ADDENDUM No. THREE

Project Name: Nature Center
White Clay Creek State Park

Contract No.: NAT25805-NATCTR
Date of Issue: Tuesday, May 26, 2026

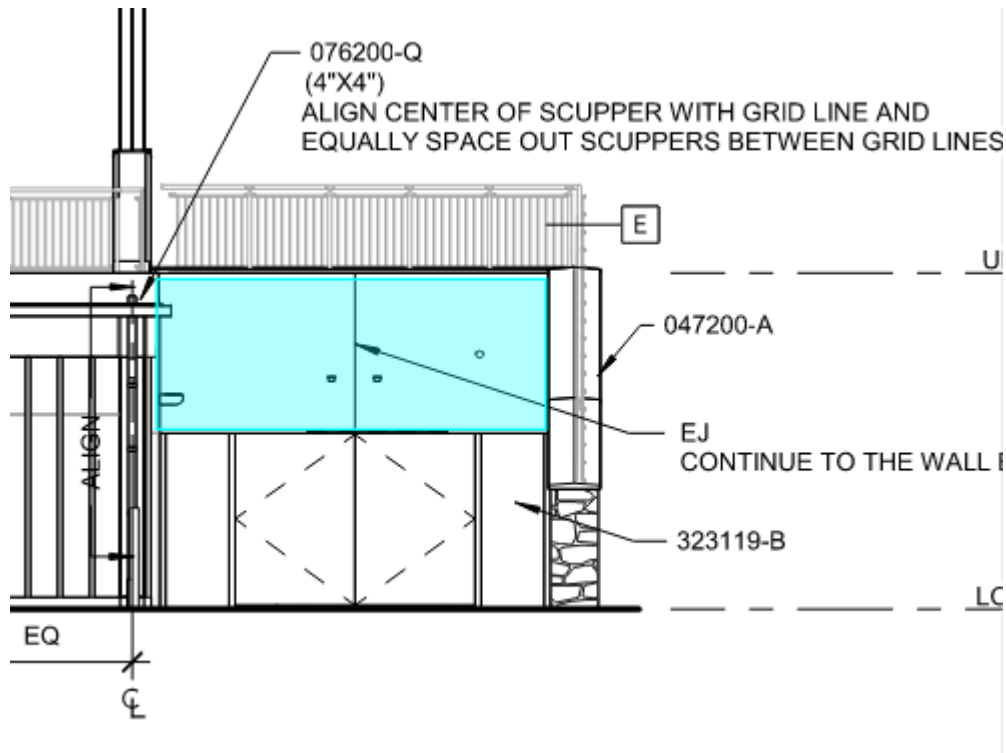
- 47 Question: Please confirm if any exposed piping is to be color coded.

Response: In finished spaces other than mechanical rooms where piping is exposed, refer to architectural drawings and specifications for painting color requirements. Within mechanical rooms, no color coding is necessary.
